8<sup>th</sup> May 2024

### Development Application No. DA2023/1869 Issues response/ Supplementary Statement of Environmental Effects Demolition works and construction of a residential flat building 54-58 Beaconsfield Street, Newport

#### Schedule of amendment to DA203/1869 Re: Letter from Northern Beaches Council dated 27 Mar 2024

Figure 1 – Plan extracts showing portion of eastern wall setback 4 metres from eastern boundary.

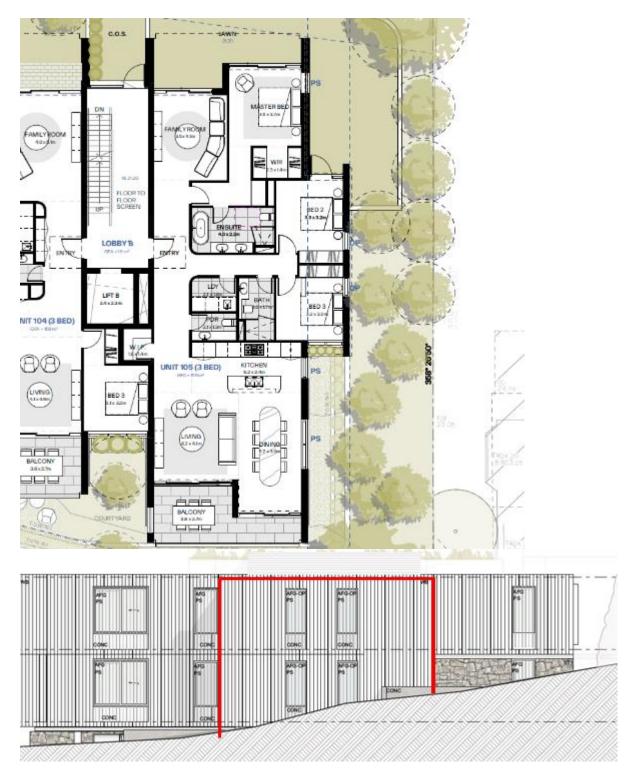
The proposed 6m eastern side setback is generally acceptable. However, a
portion of this façade is pushed toward the boundary approximately 8.75m
long. This wall presents as a large unarticulated mass to a low density
residential area and should be set back further or reduced in length to provide
an appropriate transition to the low density zoning. This is particularly
relevant as this is the only area on site which would provide 6m for deep soil
planting without any structures (noting the large amount of retaining walls to
the front setback required for the lowered POS areas).

Response: We note that Northern Beaches Council has adopted its own side boundary setback provisions at clause D10.8 of P21DCP as follows:

Where the wall height is more than 3 metres above ground level (existing), the minimum distance from any point on the external wall of the building and a side or rear boundary shall not be less than the distance calculated in accordance with the following:

$$S = 3 + \frac{H - 2}{4}$$

where

S = the distance in metres H = the height of the wall at that point measured in metres above existing ground level

The section of eastern wall referred to by DSAP is depicted in Figure 1 overpage. Based on a wall height between 5 metres and 6.2 metres for the portion of wall referred to by DSAP the required side boundary setback is between 3.75 metres and 4.05 metres. Accordingly, this portion of wall is compliant with the applicable side boundary setback control.

In relation to the DSAP concern regarding articulation and landscape opportunity we are of the opinion that the variation in the side boundary setbacks, which varied between 4 and 6 metres, provide an appropriate level of built form articulation as it presents to the adjoining R2 Low Density Residential zone with the majority of the façade setback 6 metres, well in excess of the DCP setback provision, in recognition of the sites zone boundary interface.

The basement plan and landscape plan extracts at Figure 2 demonstrate that the amended plans provide for substantial deep soil landscape opportunity along the entire eastern setback area of the development with appropriate dense landscape screening to soften screen this façade of the building.
